# SAFETY RECALL NOTICE

## **Re: Fuel Vapor Canister Vent Hose Inspection/Replacement**

**SAFETY**  
CAMPAIGN**ROADSTER**  
**WARRANTY**  
Bulletin**⚠ WARNING:** All involved customers must be notified, all involved units must be corrected as per instructions herein.Campaign no.: 2008-0013  
2009-0009  
2010-0017**December 21, 2012** Subject: **Fuel Vapor Canister Vent Hose**  
**Inspection/Replacement**No. **2010-12**

1. Fuel canister vent hose

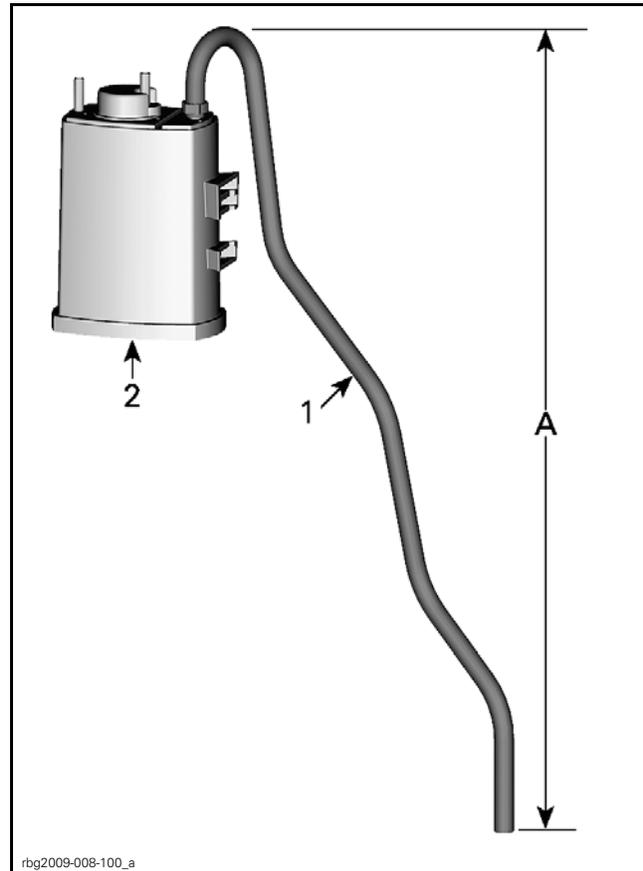
Visually inspect the fuel vapor canister vent hose.

### FUEL VAPOR CANISTER VENT HOSE

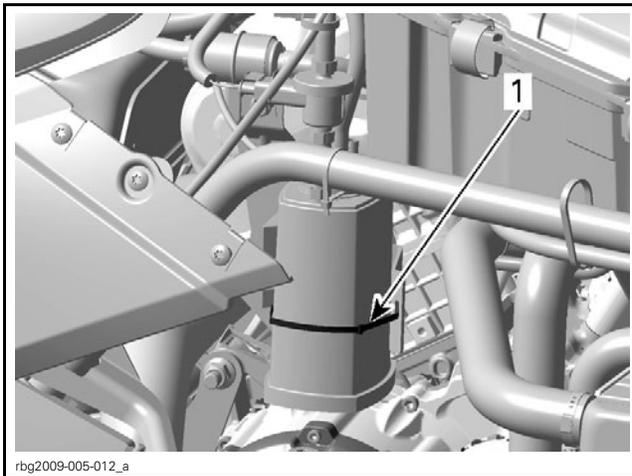
If the correct hose is installed and properly routed, no future action is required. This hose is preformed and must have the following shape. Reinstall all removed parts and go to WARRANTY procedure.

If another hose is installed, remove and discard it before installing the correct hose.

1. Preformed vent hose (P/N 709 000 277)
  2. Fuel vapor canister
- A. Approximately 480 mm (18-7/8 in)

rbg2009-005-016\_a

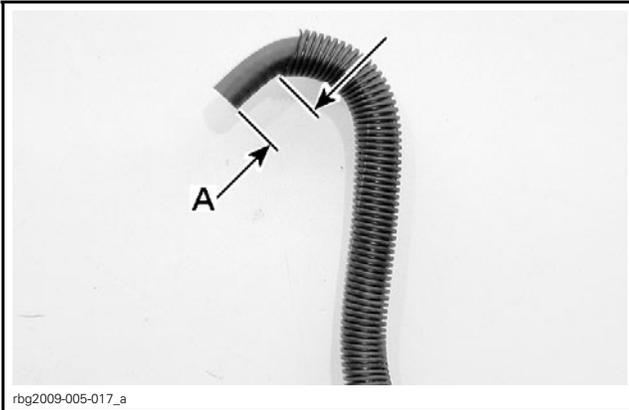
3. Install grommet into chassis hole as shown.

1. Install grommet here

rbg2009-005-017\_a

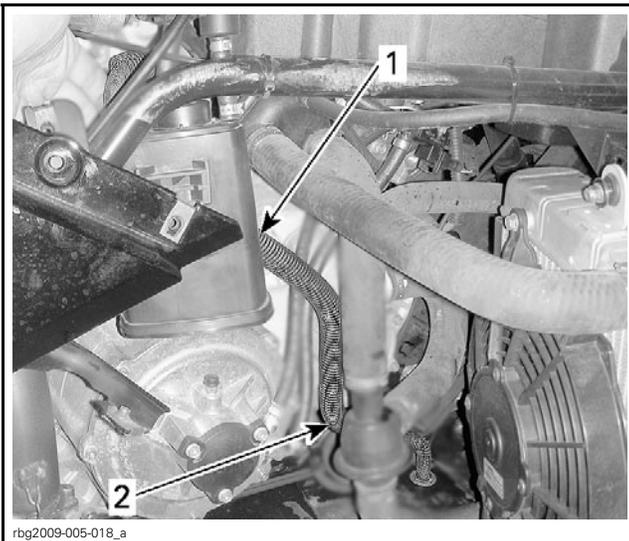
4. Insert new vent hose into corrugated tube until it reaches approximately 38 mm (1.5 in) from hose end.

A. 38 mm (1.5 in)

rbg2009-005-018\_a

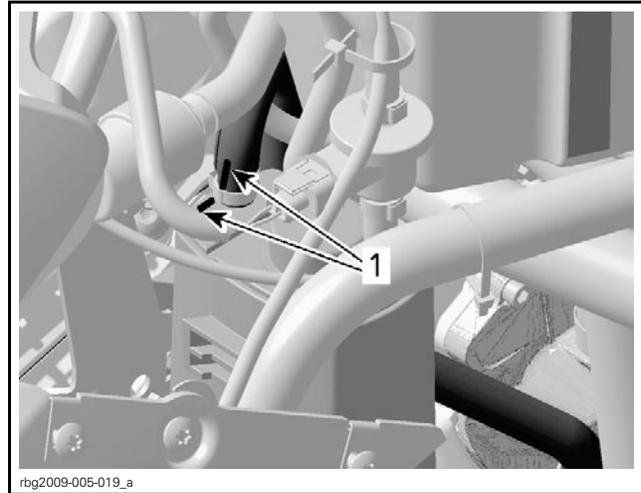
5. Route vent hose from grommet to canister as shown.

1. Hose behind canister  
2. Hose behind coolant hose

rbg2009-005-019\_a

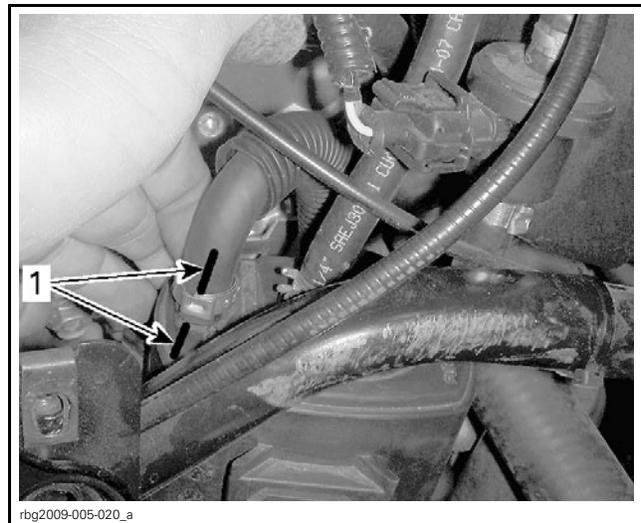
6. Loosely install vent hose and its clamp onto canister. **Do not tighten clamp yet.**
7. **Temporarily install** canister in its support.
8. Rotate vent hose so that it is properly located.
9. Trace a mark on vent hose.
10. Trace a second mark on canister aligned with the first mark.

1. Alignment marks on canister and vent hose
